Staff Report

Infill Housing Design Review Committee

File Number: 12-A-21-IH

Location: 3300 Orlando St. **Parcel ID** 69 L E 020
Zoning: RN-2 (Single-Family Residential Neighborhood)
District: Edgewood Park Infill Housing Overlay District

A.6

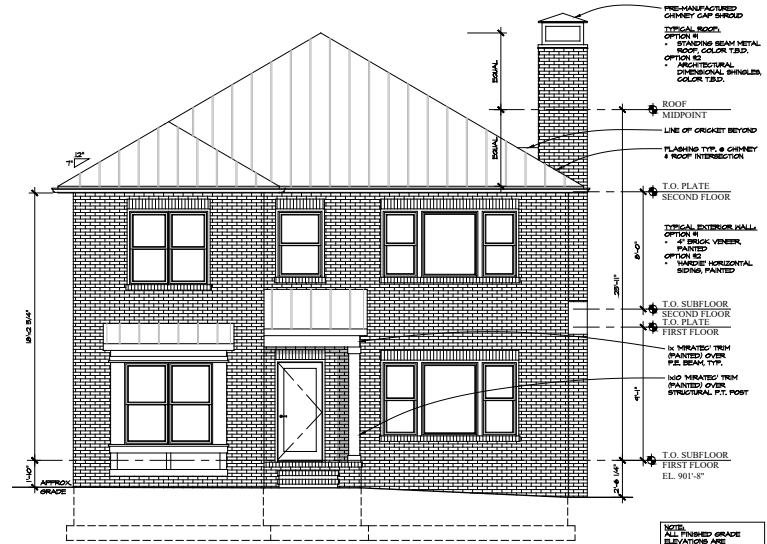
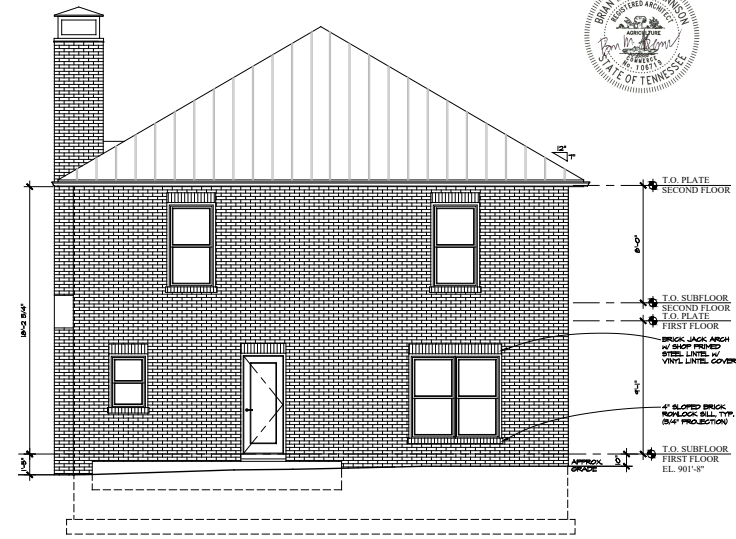
4. Overall, the two-story, three-bay façade is compatible with the block. While the majority of houses are one story, there are several two-story, three-bay historic houses on the block. The 1'-10" tall foundation height will be comparable with historic designs.

5. The house includes a 9'-8" deep, shed-roof entry porch. The porch meets the depth recommendation of the design guidelines and is compatible on a block with many Minimal Traditional entry stoops.

6. The proposed windows and doors are compatible with historic elements on the block. The right side elevation, which will be prominent on Seymour Avenue, demonstrates consistent transparency. While the design guidelines discourage "picture windows" in "pre-World War II neighborhoods," the majority of the block's houses are Minimal Traditionals, where the picture window flanked by two double-hung windows was common. The projecting bay window on the façade, brick arches, and sills also contribute to the overall design.

7. The proposed 7/12 roof pitch is compatible with the context. The design incorporates additional complexity via a projecting 7/12 hipped-roof massing on the façade. While a metal roof is unique for the context, roofing materials aren't specifically referenced in the design guidelines, only recommending that darker shades of materials be used in roofing houses.

8. Materials are appropriate within the design guidelines, which note that "brick ... and other less common

materials may be appropriate in some older neighborhoods, particularly those with a mix of architectural styles." The right elevation benefits from further detailing in the form of an exterior, two-story brick chimney. The application proposes a secondary option for both siding and roofing materials; while both meet the design guidelines, final specifications should be submitted to staff for approval prior to permitting.

- 1) Final site plan and parking to meet City Engineering standards;
- 2) Select a shade of standing seam metal or architectural shingles compatible with the block;
- 3) Final siding and roof material specifications to be submitted to staff for approval.

ARCHITECTURAL SITE PLAN
 SCALE: 1" = 10'-0"

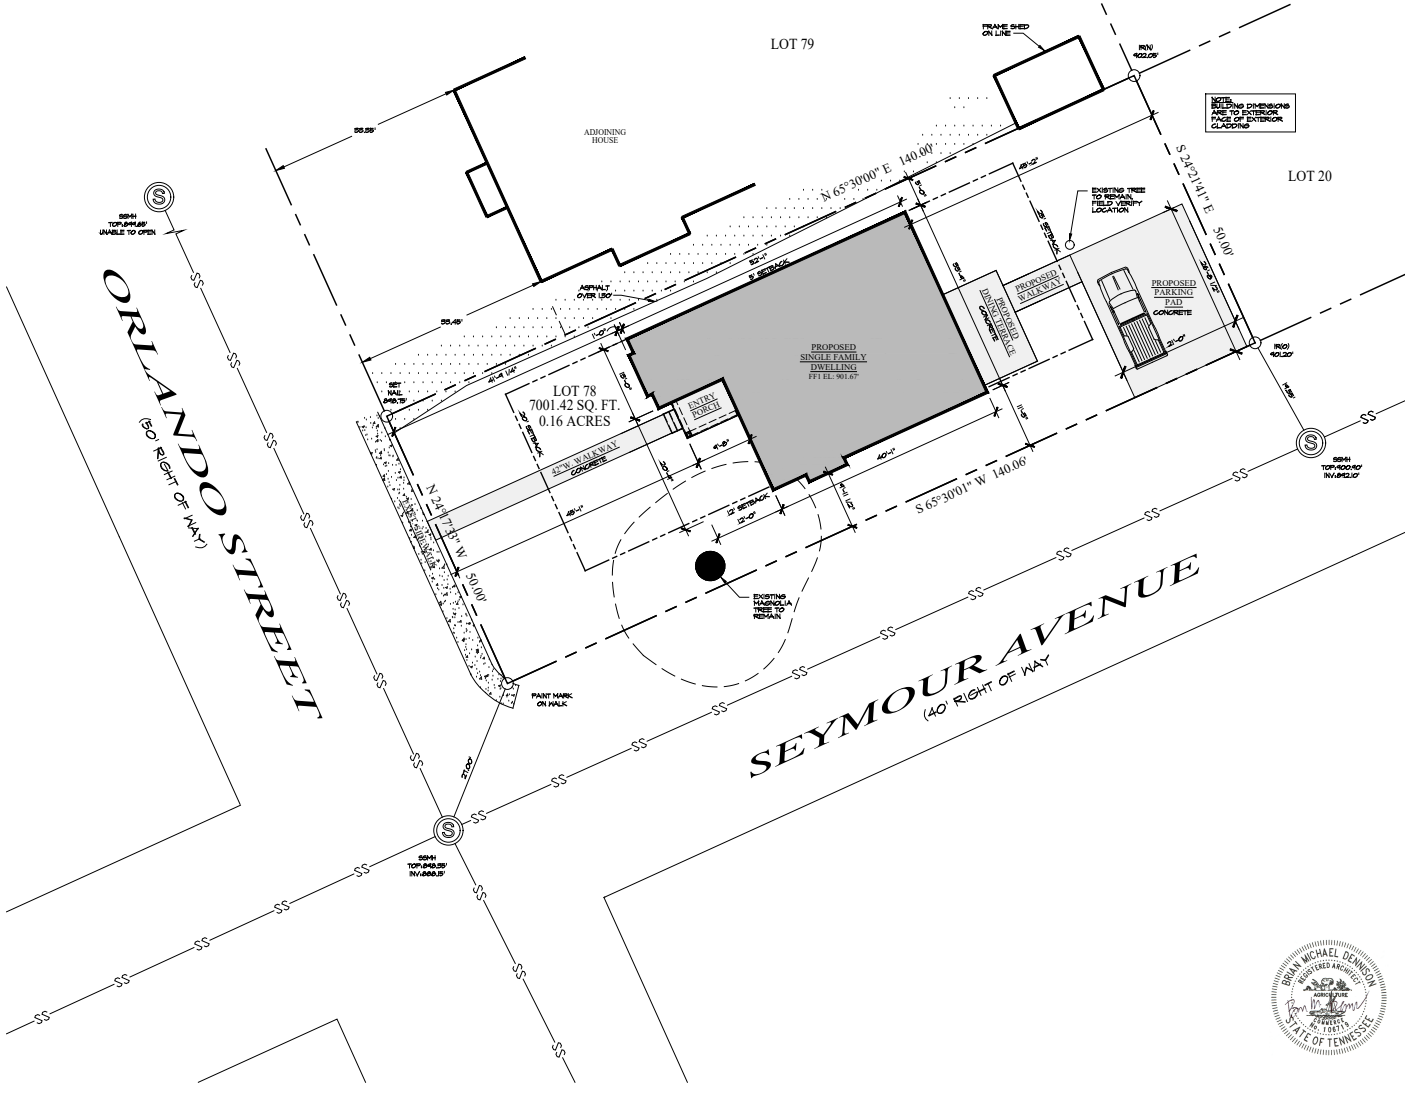
1. The proposed setback of 35'-5" on the left side of the façade and 45'-1" on the right side is slightly larger than the average of the blockface (33'). However, the proposed front setback (and reduced corner side setback of 9'-11.5") are intended to accommodate the preservation of a large, existing magnolia tree on the right side of the property. The proposed house is compatible with the adjacent house (33.45' to the front property line) and the overall character of the block. The site plan incorporates a concrete walkway to the sidewalk.

2. The block to receive new construction is characterized primarily by one-story Minimal Traditionals and Craftsman bungalows. However, there are several two-story houses on the block, including an English Cottage Revival-style two-story house in the center of the block and two two-story houses at the north end of this block of Orlando Street. The new two-story house will reflect the block's pattern of interspersed-two story houses. The proposed house is proportionate to the dimensions of the lot and stays within the base zoning code's 30% building coverage. The proposed side setbacks are compatible with the block and accommodate the magnolia tree's preservation.

3. The proposed parking meets Infill Housing design guidelines, proposed behind the primary residence and accessed off Seymour Avenue. Any final modifications to the site plan in permitting should meet City Engineering standards.
